Staff Report & Recommendation

Design Review Board

SUBJECT: DRB17-0214
4815 North Bay Road

The applicant has submitted plans entitled "Addition to Existing Single Family Residence", as prepared by **DOMO Architecture + Design**, signed, sealed and dated 01/05/18.

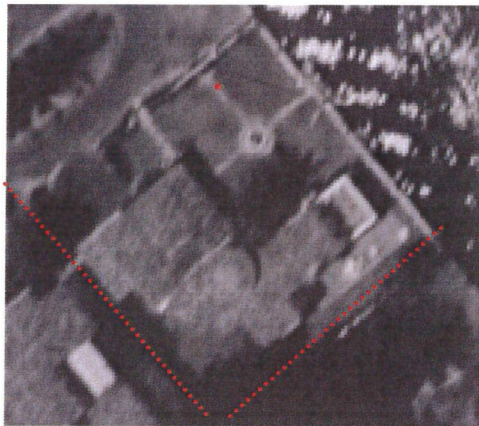
1. A variance to reduce by 13'-10" the minimum required rear setback of 20'-0" in order to construct a two-story addition at 6'-2" from the rear (east) property line.
 - Variance requested from:

The new construction will follow the non-conforming building line. However, due to the non-parallel condition of the property line, the setback of the new construction is slightly reduced from the existing 6'-9" to 6'-2". The original home was constructed significantly setback toward the rear and a pool and deck are existing on the front. This condition of the home leaves the rear as the most practical and convenient place for floor addition, in order to minimize the impact on the existing significant home. The new addition, although requiring a setback variance, is proposed in a manner that is compatible with the architecture of the building and with minimum impact on the significant home, originally constructed in 1930. Staff finds that these conditions and the retention of the structure create practical difficulties that result in the requested variances; as such staff supports variance request #1.
